CCK-2729-24
UKHC Parking Structure #8 Expansion BP#01
Project# 2565.0
ADDENDUM #5
07/13/2023

#### **PARKING STRUCTURE 8 EXPANSION**

### **ITEM NO. 5.01**

7/13/2003 Q:04:11 AM BIM 360://13\_003727 00 \_11K PS\_8 Expansion/13\_003727 00 11K PS\_8 Strict Exp

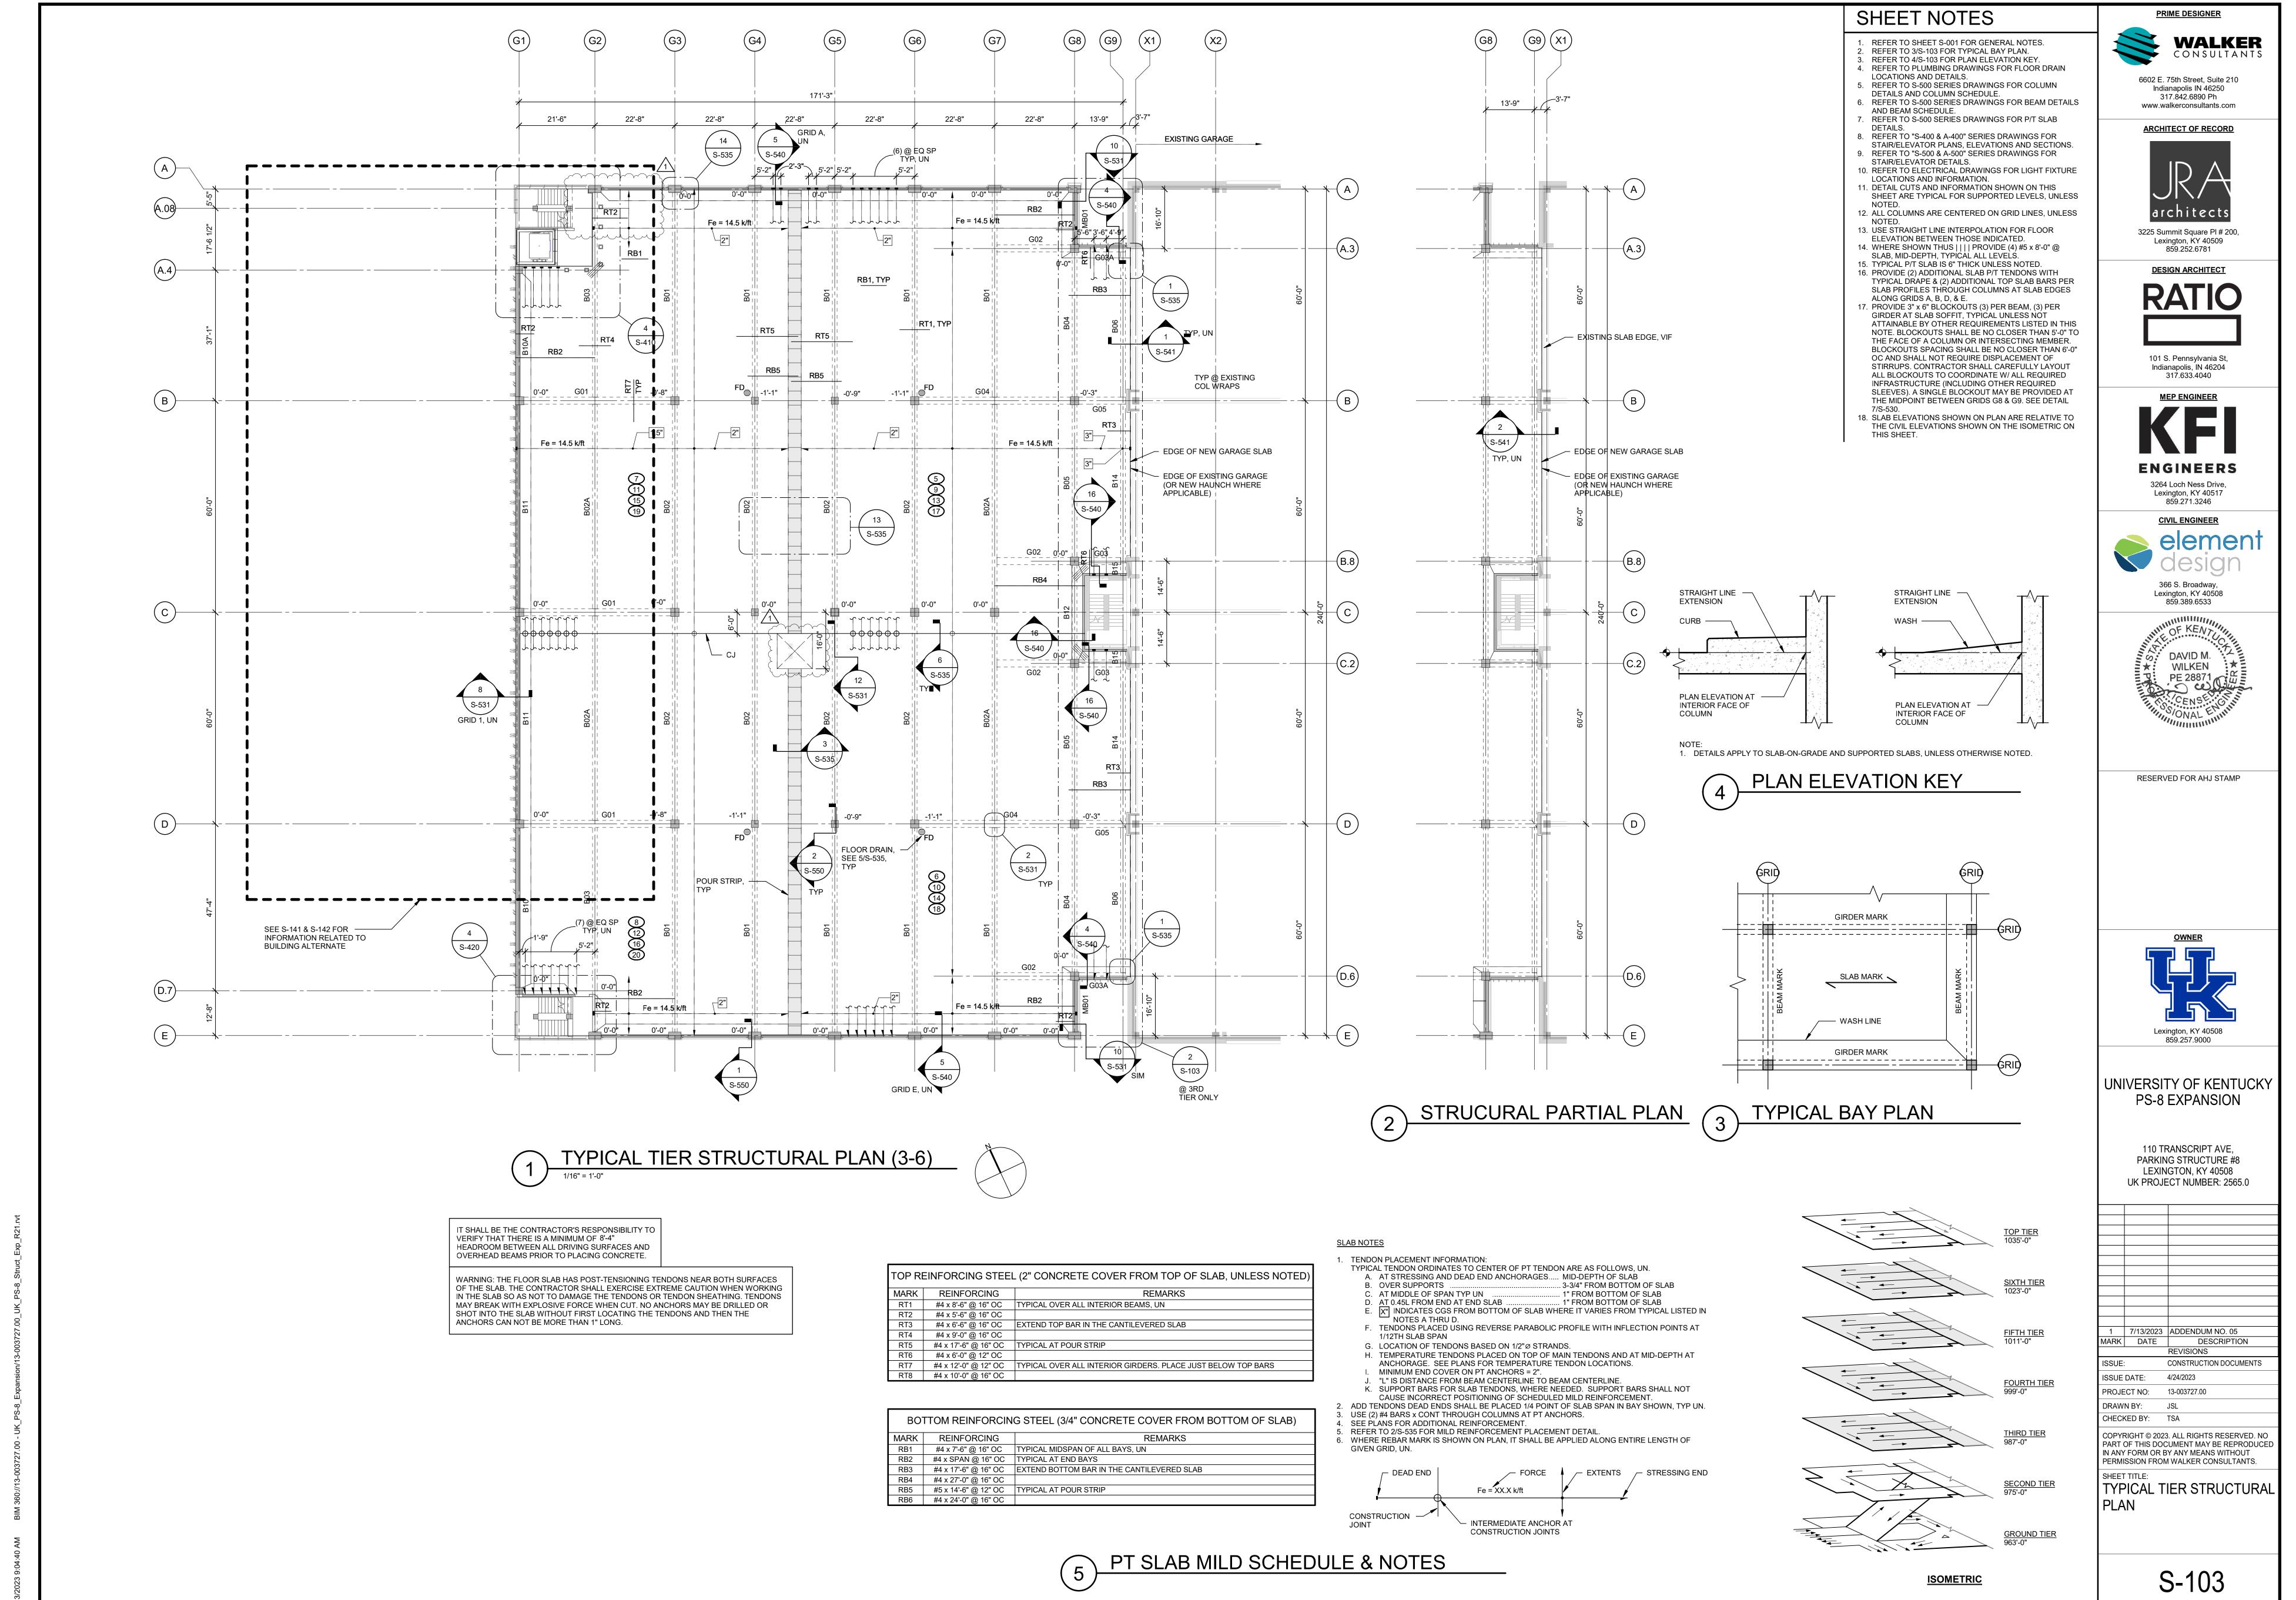
Clarified estimated bearing lengths and extents of drilled piers on S-100 as noted.

S-420

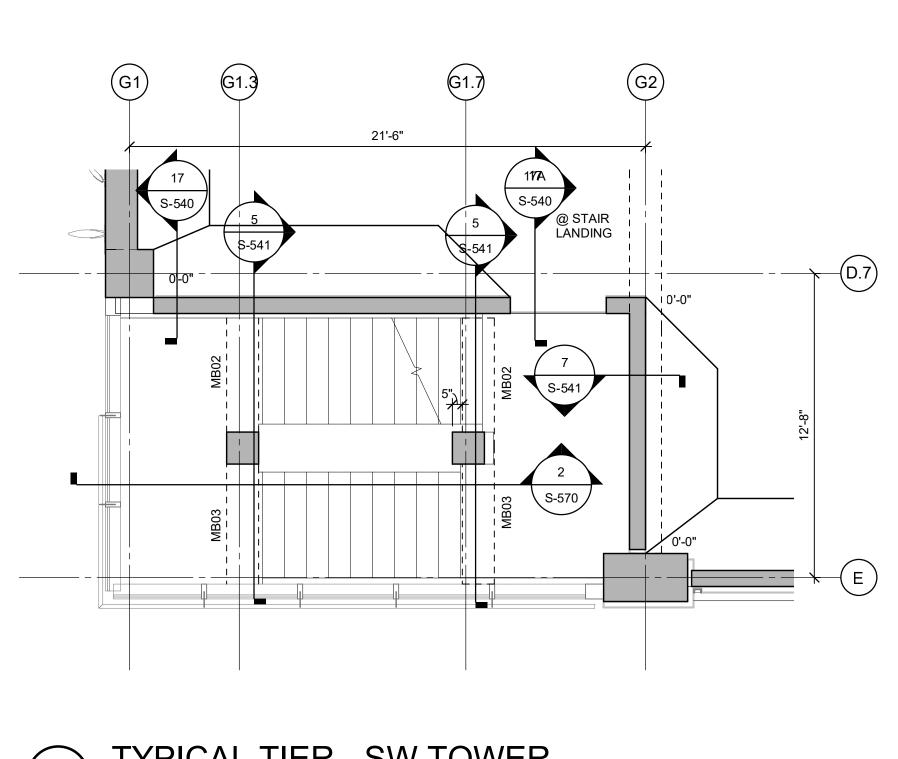
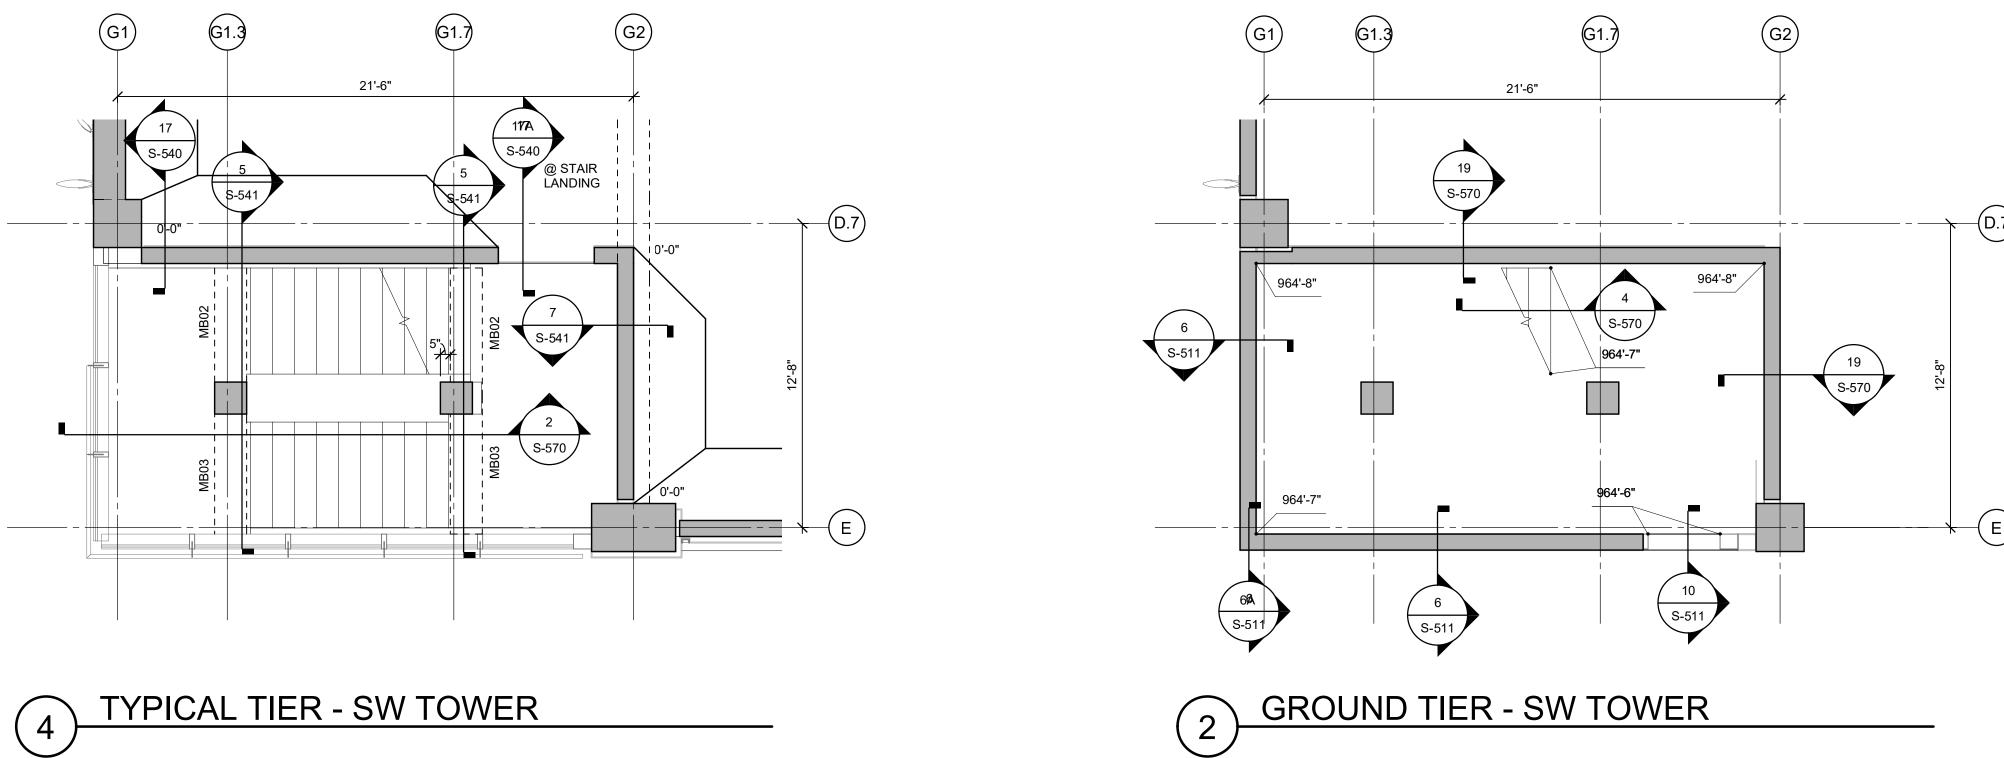
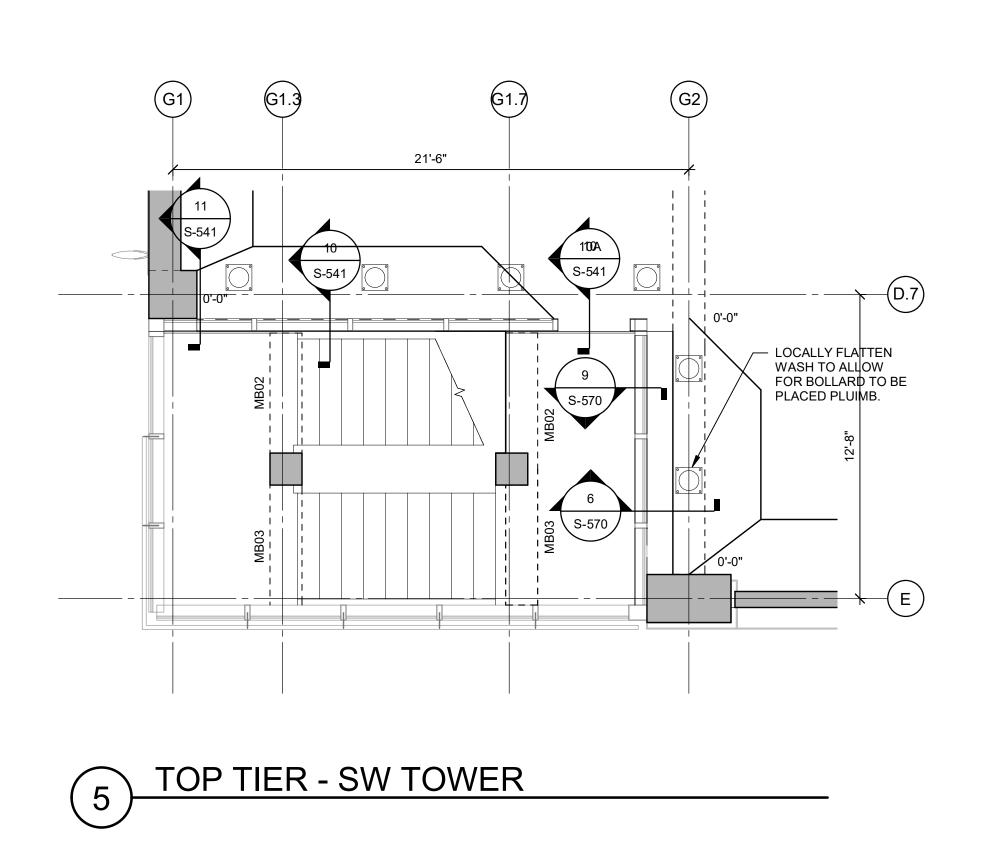
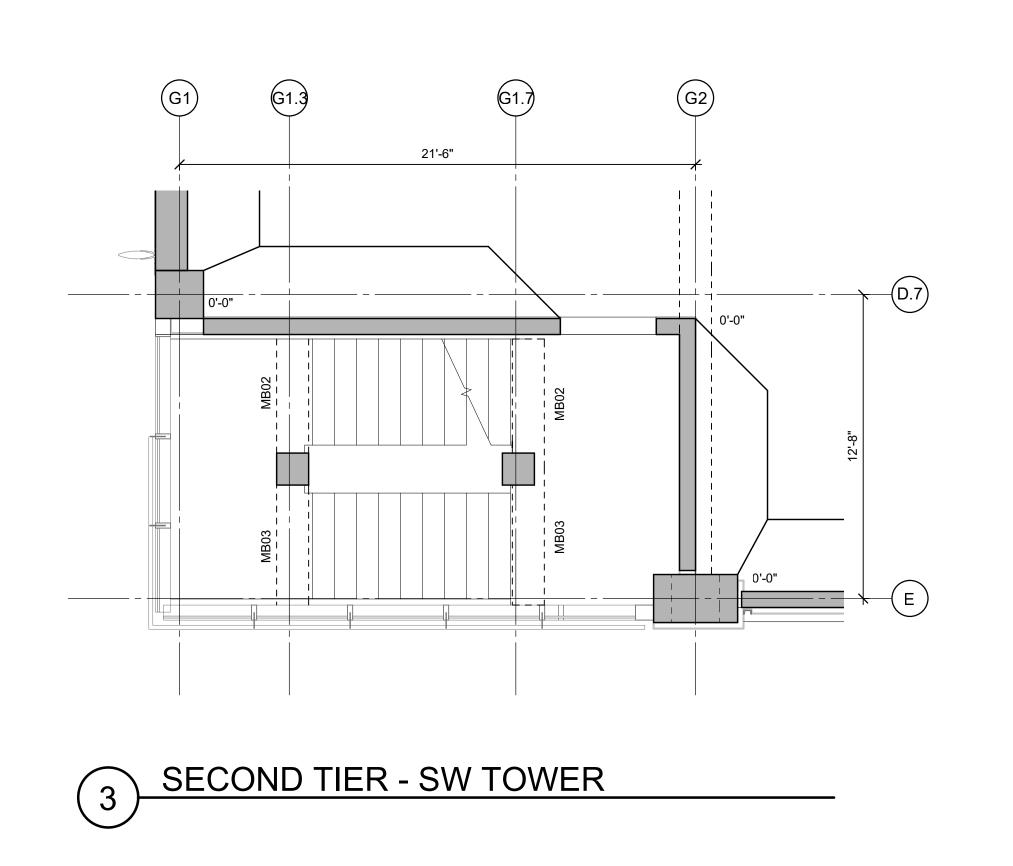
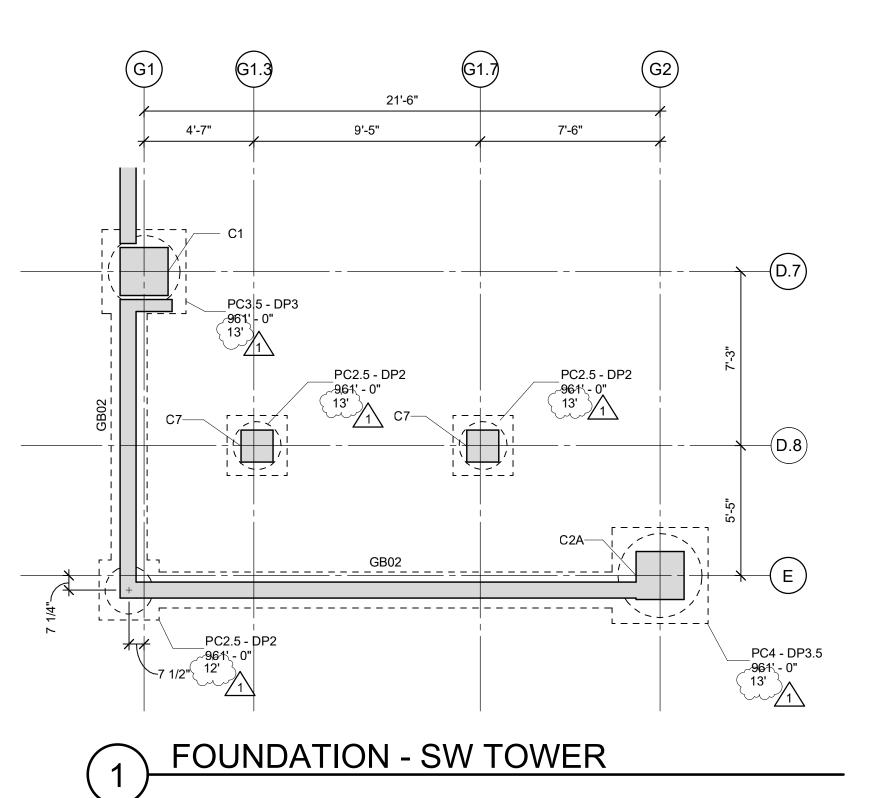
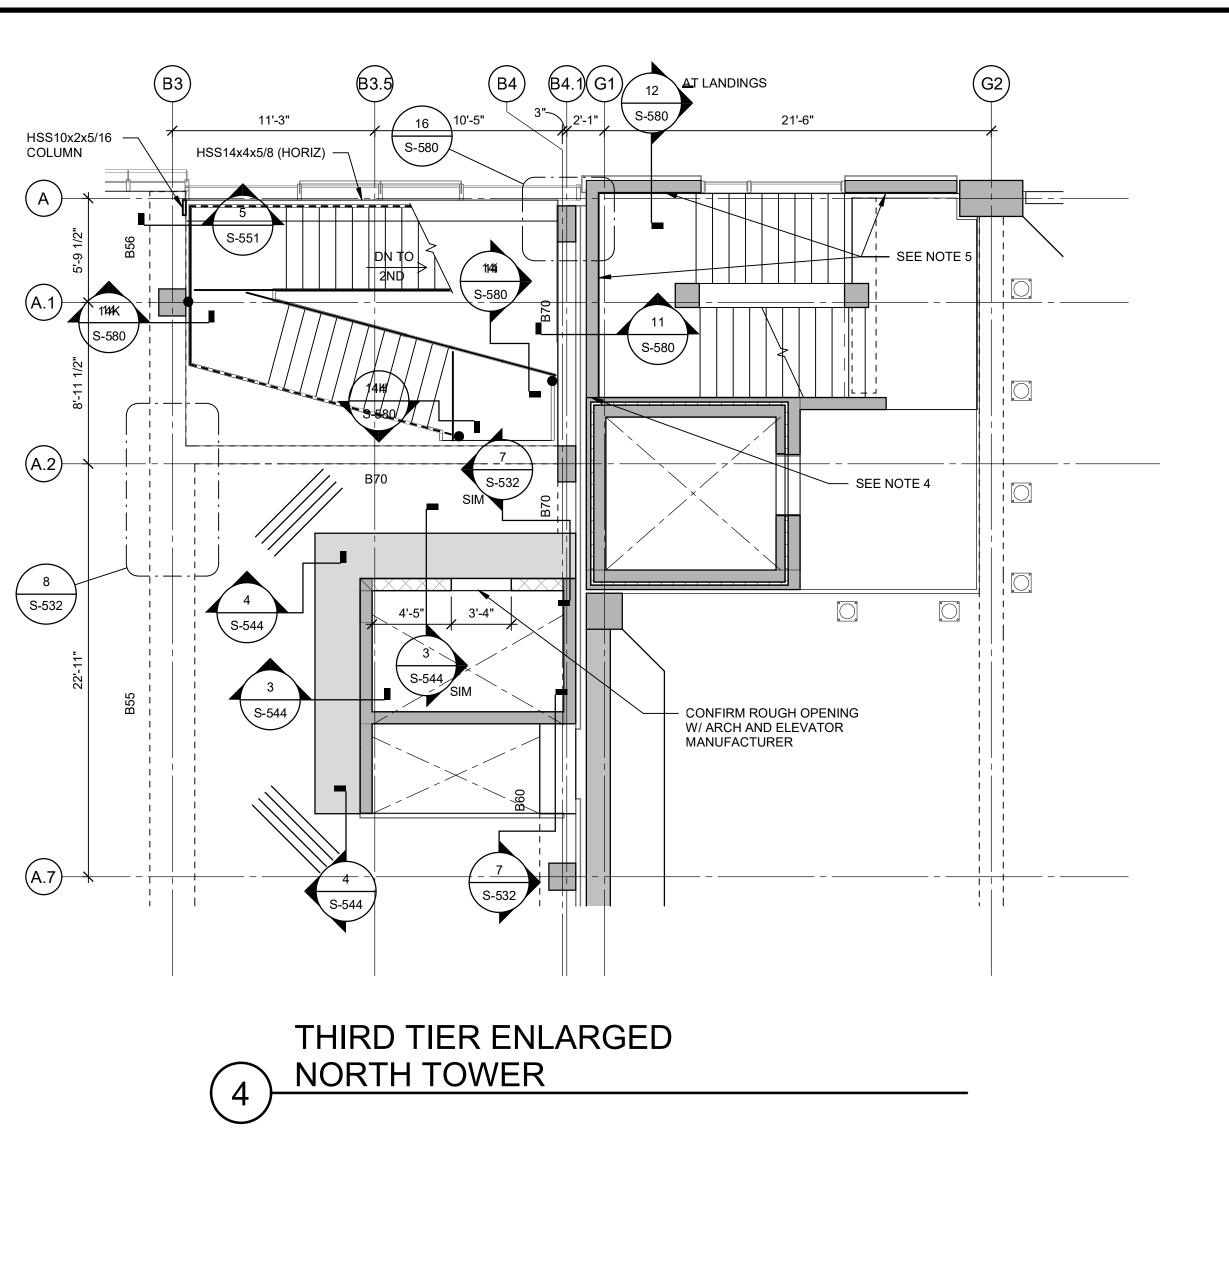
12.	to 5/S-541 instead?		
	12.	to 5/S-541 instead?  Reference detail #4/S-420. Note the detail reference for 17/S-540 next to the column at G1/D.7. Is this correct? Note that the intermediate landings will

12. 13.		Walker	
		Reference detail #4/S-420. Note the detail reference for 17/S-540 next to the column at G1/D.7. Is this correct? Note that the intermediate landings will		It is correct. The intermediate landing and dowel is dashed in and indicated to apply only at 17A
		Reference detail #4/S-420. Note the detail reference for 17/S-540 next to the column at G1/D.7. Is this correct? Note that the intermediate landings will not align with the garage slabs.		It is correct. The intermediate landing and dowel is dashed in and indicated to apply only at 17A  Details P, Q/A-621 are inconsistent with the drawings. The drawings show 2° insulation, but the key
